MANDATORY SERVICE BULLETIN NO. MSB 62-027 REV. 1 **SUPERSEDES MSB 62-027 REV. 0**

Modification to the installation of the static ports.

WORK INSTRUCTION WI-MSB 62-027 REV. 0

Figure 1. Left: original static port installation. Right: exploded view of original static port installation.

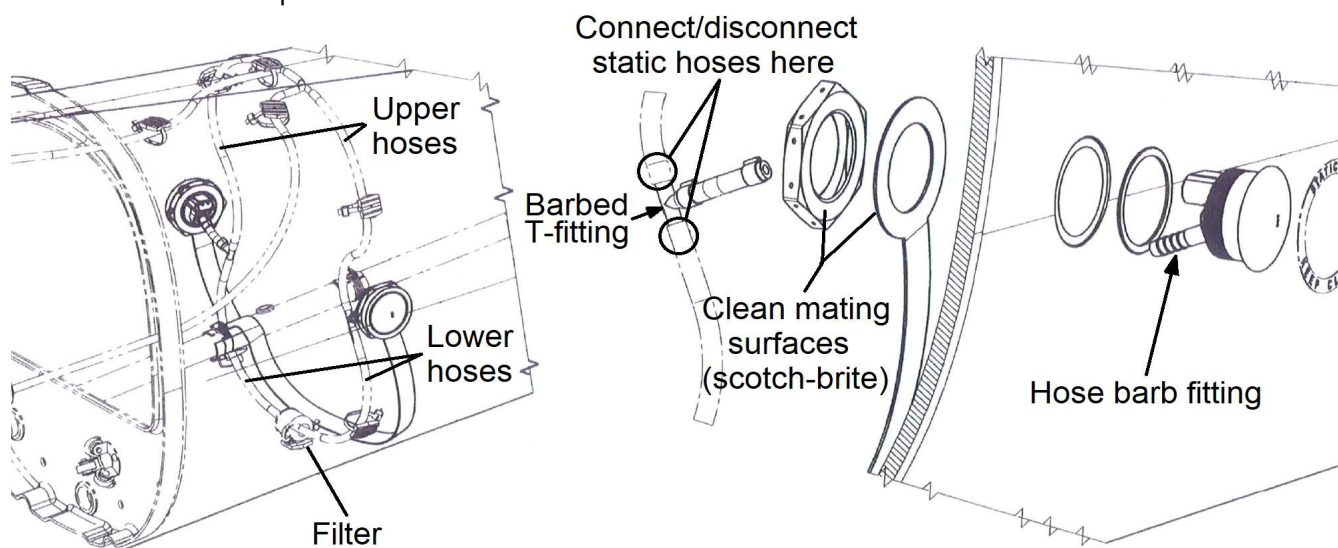
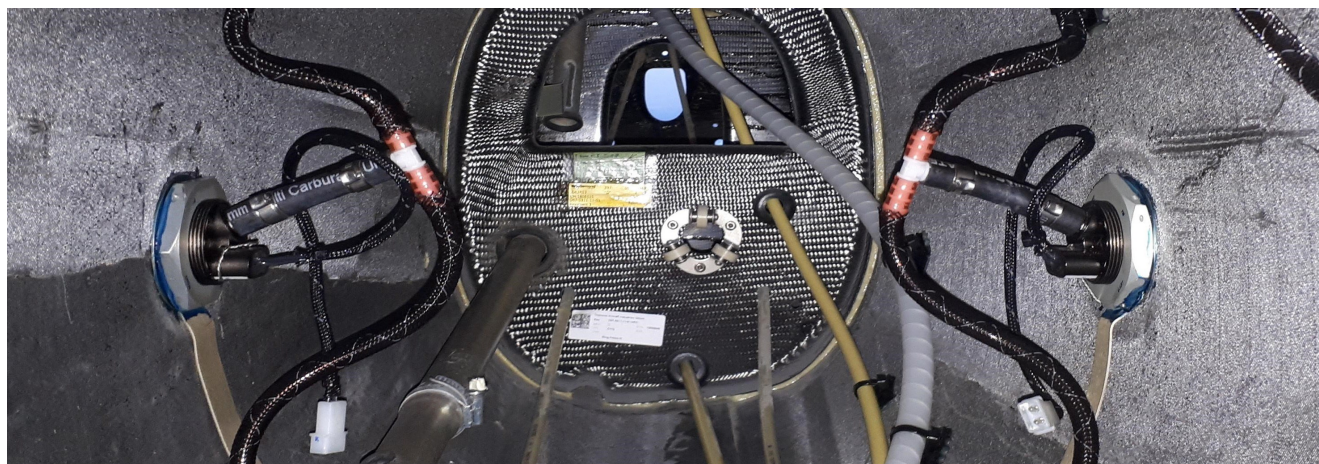
It has been found that during certain adverse weather conditions, in combinations with certain flight conditions, that water can enter the DA 62's static ports, causing erratic instrument readings. Furthermore, use of the aircraft's anti-icing system in combination with certain flight conditions has resulted in anti-icing fluid entering the static ports, causing erratic instrument readings. This service bulletin describes a modification to the installation of the static ports to better allow fluids to drain out of the port.

5. Disconnect the electrical cable from the static port.
6. Disconnect the static hose connections at the circled locations in Figure 1 (pull off the upper and lower hoses from the T-fitting). **DO NOT REMOVE THE OETICKER CLAMPS.**
7. Note the orientation of the holes in the static port (vertical) as shown in Figure 3.

Figure 2. New installation of the static ports with the hose barb fittings pointing upwards.

12. Replace the lower static hoses with the new hoses prepared in step 4.
13. Insert the static port into its hole at the rear of the fuselage. Ensure none of the holes in the static port are blocked. Pay attention to the new orientation:
 - A. The three small static pressure port holes on the static port cap are vertical, as shown in Figure 3. The three holes must form a line which lies $\pm 2^\circ$ from vertical.
 - B. The hose barb fitting is now pointing upwards inside the fuselage (as shown in Figure 2), i.e. turned 180° from when the static port was removed.
14. Cut the new lower static hoses to an appropriate length. They must cover all the barbs of the T-fitting at its new location, but not be too long such that the hoses are pinched.

15. Push the lower hoses onto the barbed T-fitting.
16. Cut the upper static hoses to an appropriate length. They must cover all the barbs of the T-fitting at its new location, but not be too long such that the hoses are pinched.
17. Push the upper hoses onto the barbed T-fitting.
18. Using EASY GASKET (item 4), seal the static port and the shim ring (if installed) into the fuselage from the outside.
